Access Compliance Report

Public Rights-of-Way

(Curb Ramps)

Intersection ID: 17062	Main Street: IDLEWILD_RD	Cross Street: MONROE_RD	Location: SE
ADA ID: AE7878E2CFB0	Ramp Type: PerpDiag	Initial Pass/Fail: Fail	Overall Compliance: No
Severity Score: 12.5			
Codes/Mitigation Info/Possible Solution		Field Measurements/Component Compliance

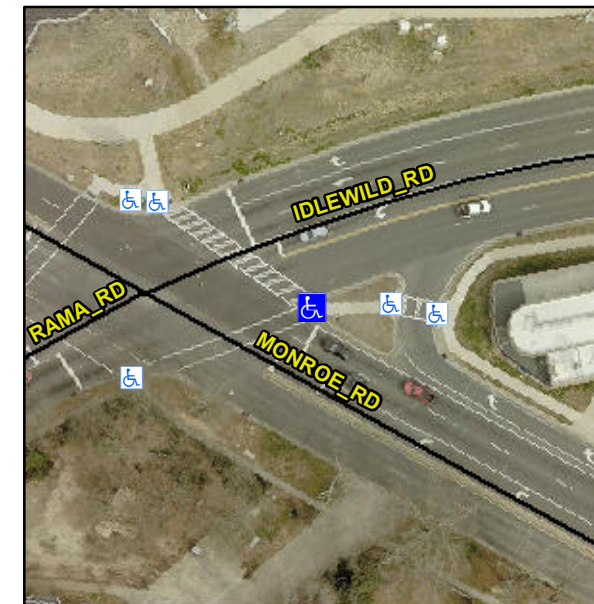
Not Found, R304.2.2

Compliance	Description	Data	Compliance	Description	Data
N/A	Ramp Length (in)	96.0	No	Ramp Slope (%)	10.2
Yes	Ramp Width (in)	77.0	Yes	Ramp XSlope (%)	0.5
N/A	Flare Type LT	N/A	N/A	Flare Type RT	N/A
N/A	Flare Slope LT (%)	N/A	N/A	Flare Slope RT (%)	N/A
N/A	Flare Traversable LT?	N/A	N/A	Flare Traversable RT?	N/A
N/A	Landing Length (in)	N/A	N/A	DWS Provided?	N/A
N/A	Landing Width (in)	N/A	N/A	DWS Contrast?	N/A
N/A	Landing Slope (%)	N/A	N/A	DWS Length (in)	N/A
N/A	Landing X Slope (%)	N/A	N/A	DWS Full Width?	N/A
N/A	Landing Curb? (Y/N)	N/A	N/A	DWS Offset (in)	N/A
N/A	Shared Landing?	N/A			
N/A	Gutter Ponding?	N/A	N/A	Gutter Slope (%)	N/A
N/A	Gutter Lip Ht (in)	N/A	N/A	Gutter X Slope (%)	N/A
N/A	Painted X Walk1?	Yes	N/A	Painted X Walk2?	Yes
	X Walk 1 Direction	To NW		X Walk 2 Direction	To SW
N/A	X Walk 1 Width (in)	128.0	N/A	X Walk 2 Width (in)	86.0
	X Walk 1 Slope (%)	0.7		X Walk 2 Slope (%)	1.3
	X Walk 1 X Slope (%)	1.6		X Walk 2 X Slope (%)	1.8

Remove & Replace Curb Ramp With Two New Directional Ramps or Equivalent.
